TT382 – July 14, 2008 - Heated Seat / Accessory Connectors for CVO Ultra
Heated Seat / Accessory Connectors for CVO Ultra

CVO Ultra Heated Seat Harness Connector

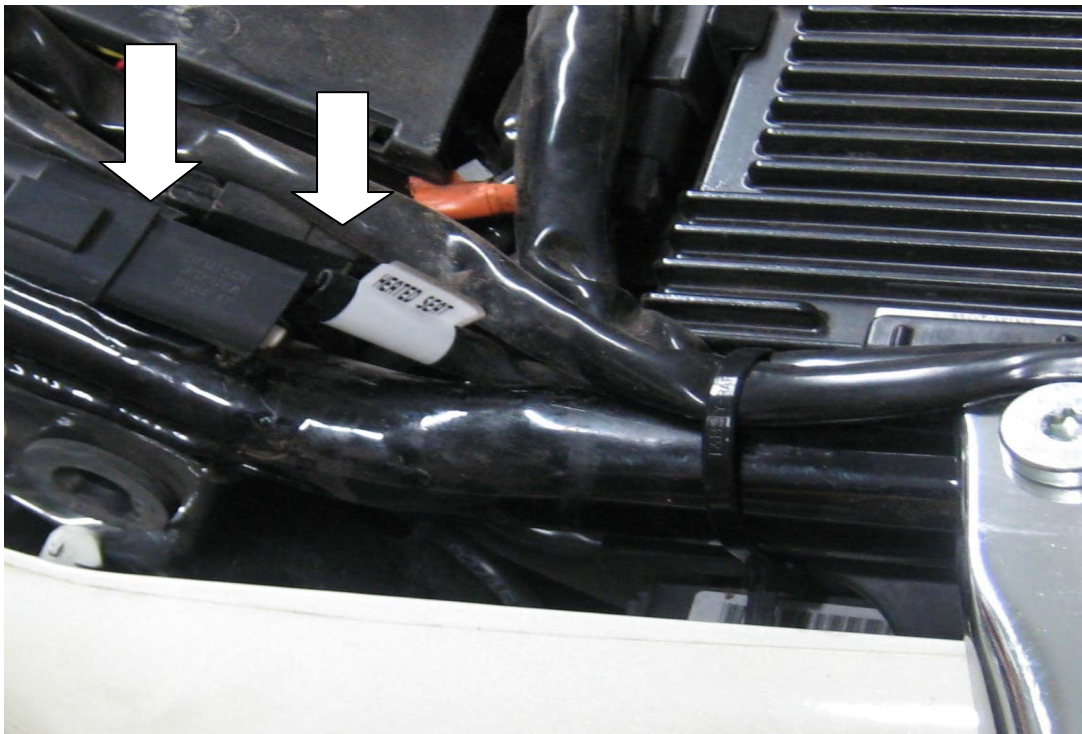
A running change was made to the wire harness in **Mid-April** to include a label near the harness-side connector for the heated seat. This was added to ease identification. (see below)

Remember, on earlier bikes the two connectors are not labeled. Please be sure to identify the correct connector for the heated seat when installing. You will notice that the heated seat connector has two wires only, O/R and BK. It is always a best practice to verify that the heated seat works after any service that requires the seat to be removed.
